Service Bulletin

New WLAN Adapter Available for Solving Performance and Connection Reliability Issues

This document informs about the availability of a new WLAN Adapter for the DX-D 100 solution.

Affected serial number(s) / batch: This Service Bulletin is only applicable for XP-based DX-D 100 systems.

Figure 1

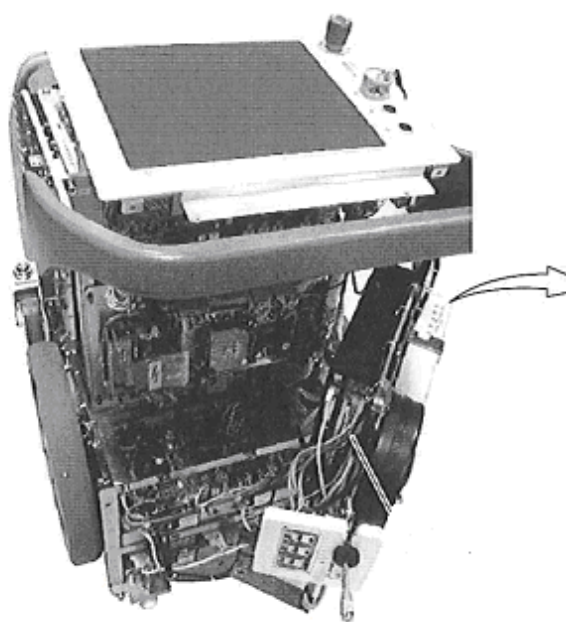
- (1) Remove the frame that encloses the touch screen monitor.
- (2) Remove the rear cover.
- (3) Open the PC unit (pivot PC module on the right).

Figure 2

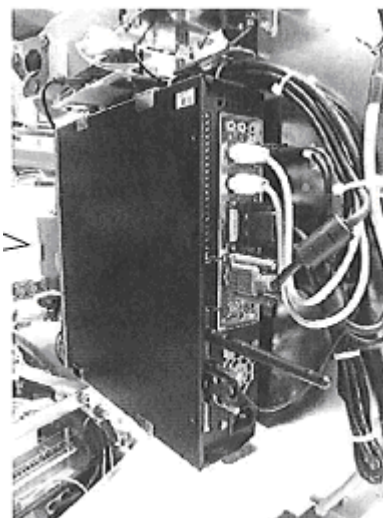
- (4) Once the back cover has been dismantled from the mobile unit, open the PC module and unplug all the PC connectors (see Figure 3 below).

Figure 3

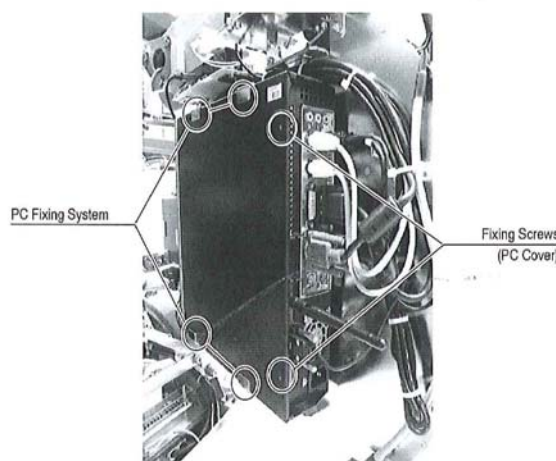
- (5) Loosen the screws of the PC fixing system to dismount the PC.
(6) Place the PC on a table and dismount the cover by removing the fixing screws (see figure 3).

Figure 4

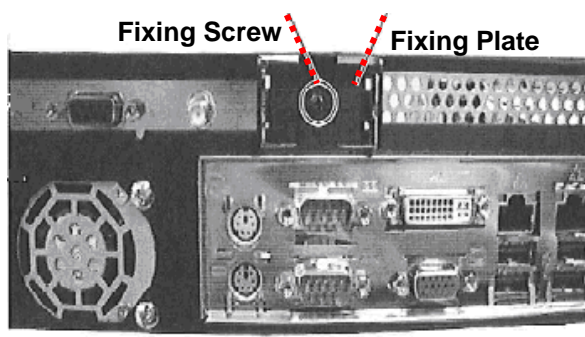
- (7) At the back of the PC, remove the fixing screw and dismount the fixing plate in order to remove the auto ON/OFF PCB in the next step.

Figure 5

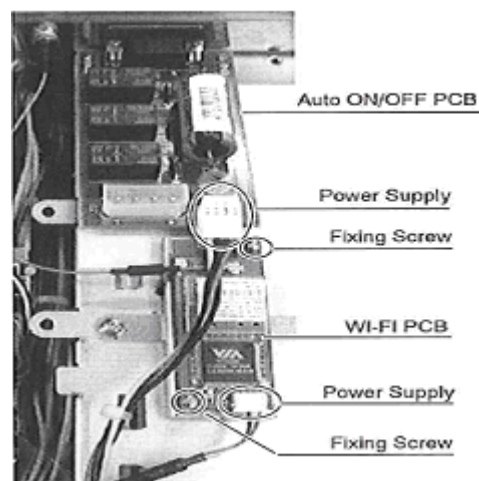
- (8) Inside the PC, remove the WiFi fixing screws, disconnect the power supply cables of the WiFi PCB and the auto ON/OFF PCB, then remove both boards.

Figure 7

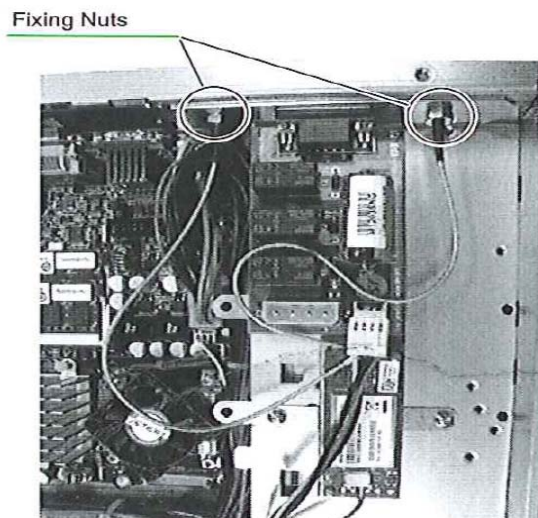
- (10) Install the new auto ON/OFF mobile PCB inside the PC.
(11) Connect the power supply cables of each board.

Figure 8

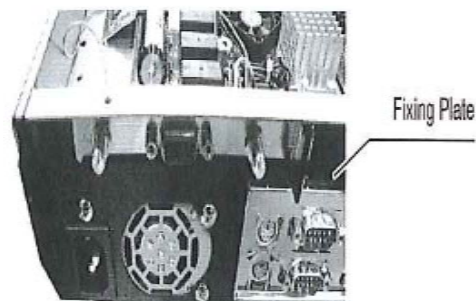
- (12) At the back of the PC housing, fasten the fixing plate.
